EKI TECHNICAL PRESENTATION #35

COSUMNES SUBBASIN GSP DEVELOPMENT

COSUMNES SUBBASIN WORKING GROUP MEETING

RESPONSE TO PUBLIC COMMENTS (1 OF 13)

SGMA MONITORING NETWORK (8 OF 8)

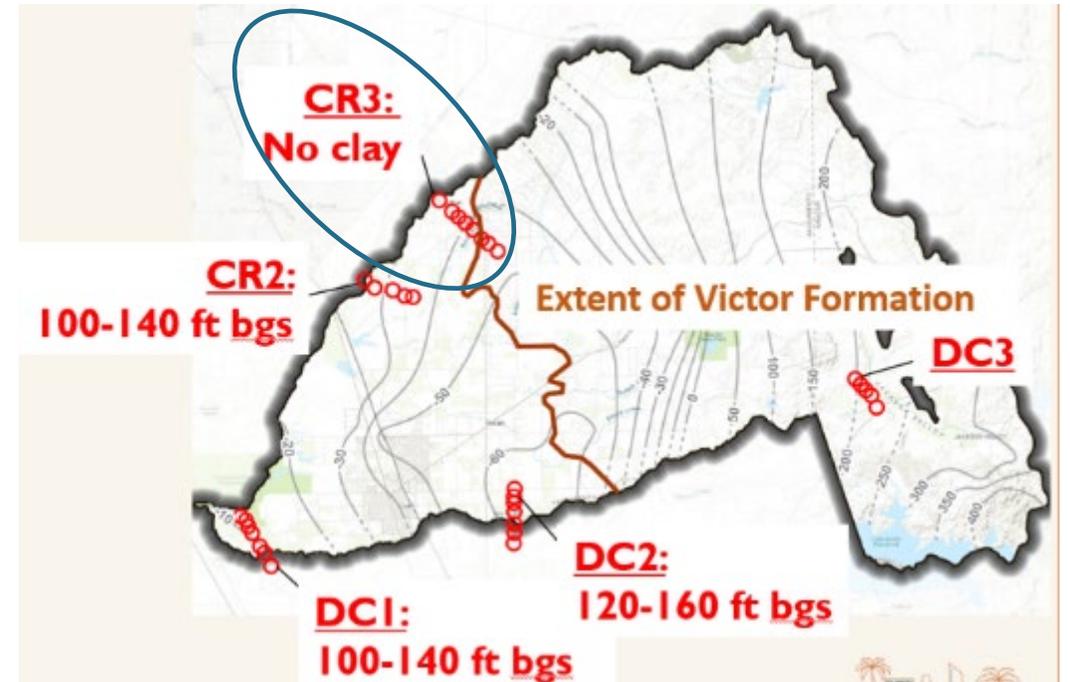
Comment #55: **The GSP fails to present evidence demonstrating that the groundwater levels or pumping within the Principal Aquifer are independent from groundwater stored in these perched areas.**

Response: Add clarifying text on using existing and planned multiple depth monitoring well sites to evaluate possible perched groundwater conditions as part of monitoring program.

Explanation: *The hydraulic interaction, if any, between perched groundwater and pumped depth intervals of the Principal Aquifer can be elucidated from water levels in variable depth monitoring wells. There is currently one multi-well cluster site in the Basin, and two more planned for construction (one of the two is planned specifically within a suspected area of perched groundwater). This data will be collected and evaluated accordingly as part of the monitoring program. Pumping tests can also provide insight into possible hydraulic connections between depth intervals. As described in the GSP, these tests could be conducted when opportunities arise like new well construction, PMA feasibility assessments, and so forth.*

From: EKI Technical Presentation #27
April 21, 2021 Working Group Meeting

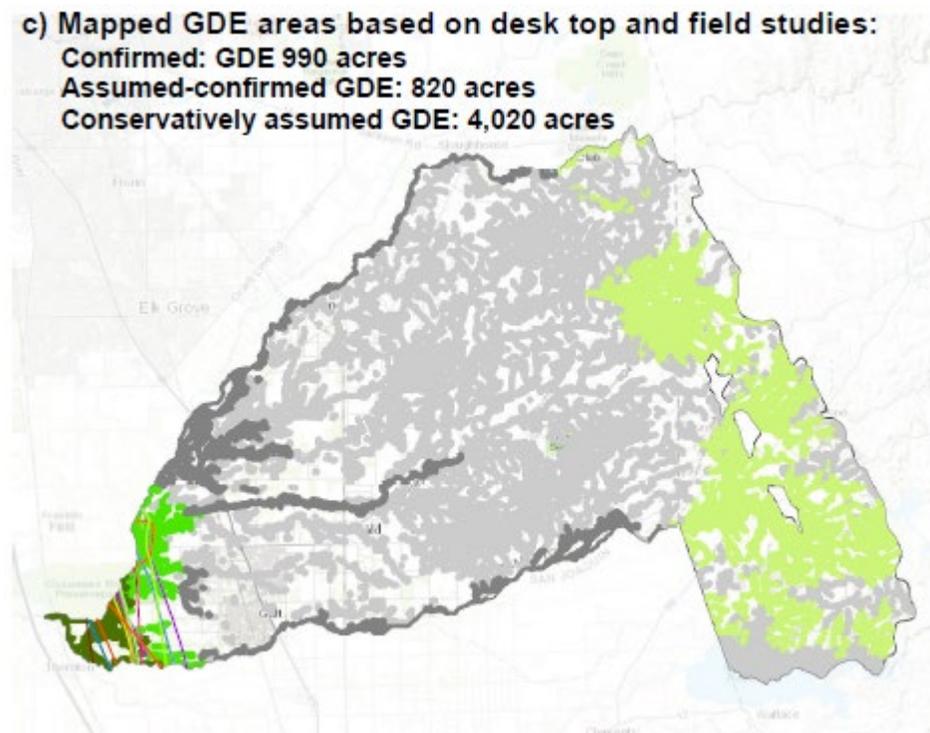
Comment #114: **The extensive Clay Layer under the cone of depression was dispositively identified in Geoconsultants... This best available science documenting by far the largest and most important geological feature in the Cosumnes Basin, directly over the cone of depression.** (Jay Schneider)

Response: Include map showing ETS results and note in the GSP that the extent and hydrologic effects of the inferred clay bed is a data gap to consider in PMA design and implementation.

Explanation: *The GSP concluded that "The inferred clay bed is likely not continuous across the Basin (note the clay is absent in transect CR3), but where present can impede percolating recharge, support a relatively shallow water table, and result in greater drawdowns as a result of groundwater extractions."*

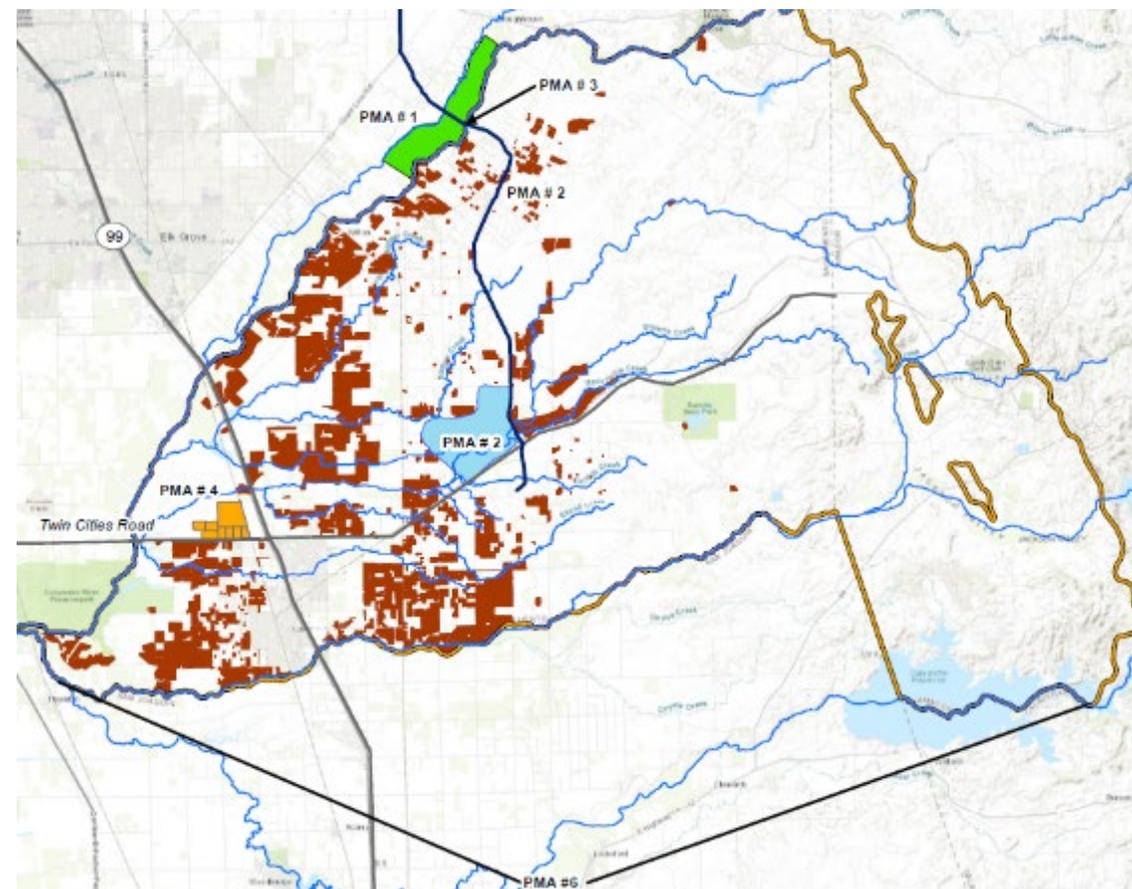
Comment #53: It is unclear how the climate change scenarios may impact the realized groundwater benefits of the implemented PMAs, but assuming that the groundwater storage benefits are similar to the 9,000 AFY modeled with the projected baseline conditions, additional PMAs may be necessary to meet subbasin sustainability objectives under an uncertain climate future. (CDFW)

Response: Include model results from scenario that combines PCBL, Central Tendency climate change, and PMAs in Table WB-10.

Explanation: *The model was utilized to simulate the PCBL with PMAs scenario with the Central Tendency climate change scenario and results indicated the average annual storage change decreased from a net gain of 7,100 AFY (without climate change) to a smaller gain of 500 AFY (with climate change). The GSP regulations do not specifically require an assessment of PMAs under climate change, but rather how they will trigger implementation of PMAs should climatic conditions materialize that require an adaptive response by the GSAs. Should climate result in overdraft conditions even with the implementation of planned PMAs, the GSP describes additional PMAs that could be implemented.*
